STAFF REPORT  
(Preliminary Plat)

**CASE NUMBER:** SUB 2003-136 -- KRUG NORTH ADDITION

**VICINITY MAP**

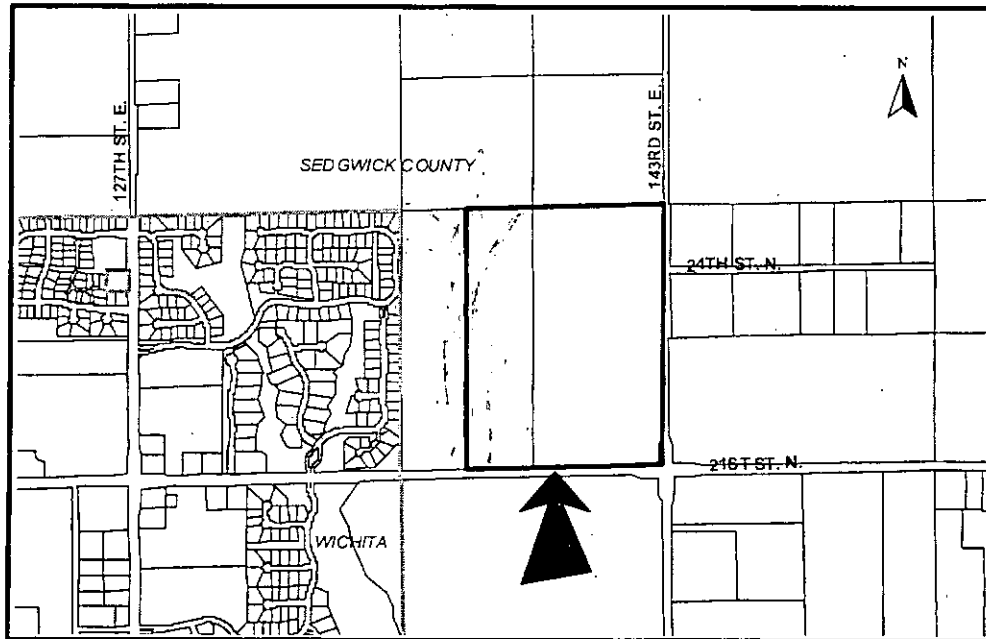
*How to serve w/  
sewer ?  
Sewer main ?*
